SEQUOYAH NUCLEAR PLANT (SQN) - UNITS 1 AND 2 - RESPONSE TO NRC SAFETY  
EVALUATION (SE) ON THE CONFORMANCE WITH THE STATION BLACKOUT (SBO) RULE  
(10 CFR 50.63)

Response to NRC's Station Blackout (SBO)  
Analysis for Sequoyah Nuclear Plant (SQN)

FIGURE 1

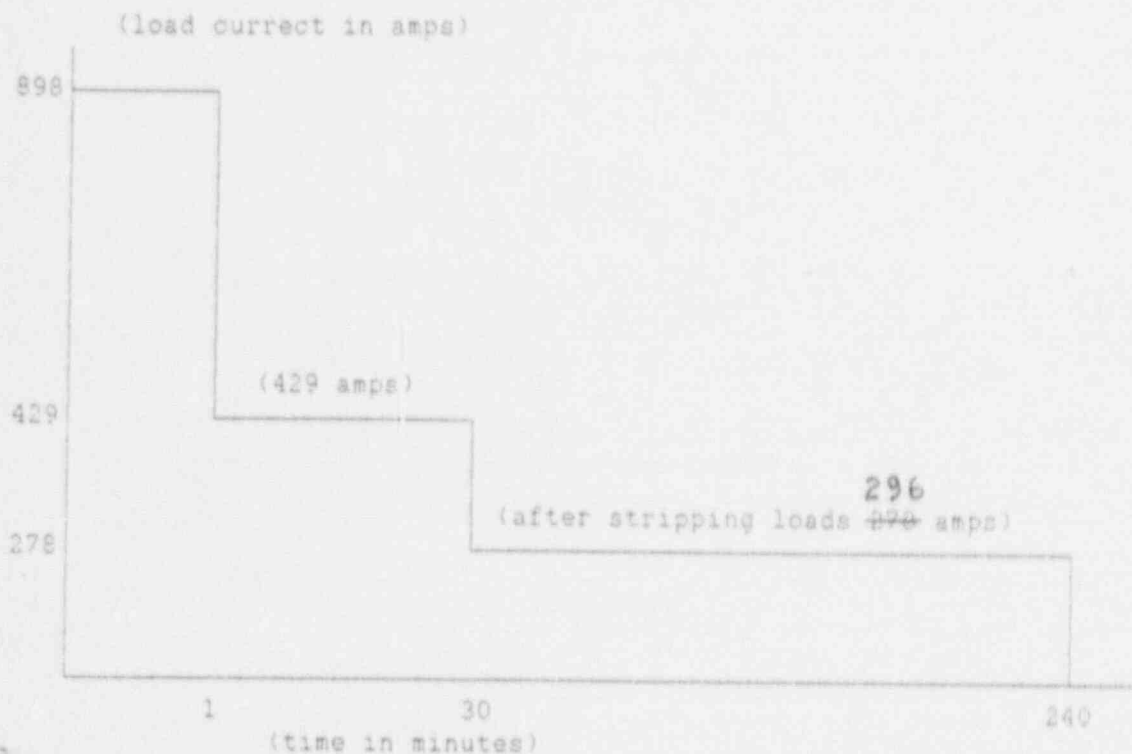
"The licensee should submit the battery capacity calculation and identify the loads that will be shed. The battery capacity verification and any resulting modification or procedure changes should be included in the documentation supporting the SBO submittals that is to be maintained by the licensee."

The load tabulations result in the following loads and times for Vital Battery 1. These load values will be used to verify that the Vital Batteries can meet the four hour duty requirement imposed by the plant/power system SBO evaluation. The duty cycle curve is then constructed from the load data.

From: t= 0 seconds to 5 seconds-	897.53 amps	] Per IEEE 485, The load current is assumed to be 898 amps for first min.
t= 5 seconds to 1 minute "	649.23 amps	
t= 1 minute to 30 minutes-	428.91 amps	
t= 30 minutes to 4-hours-	<del>296.14</del> <sup>296</sup> amps
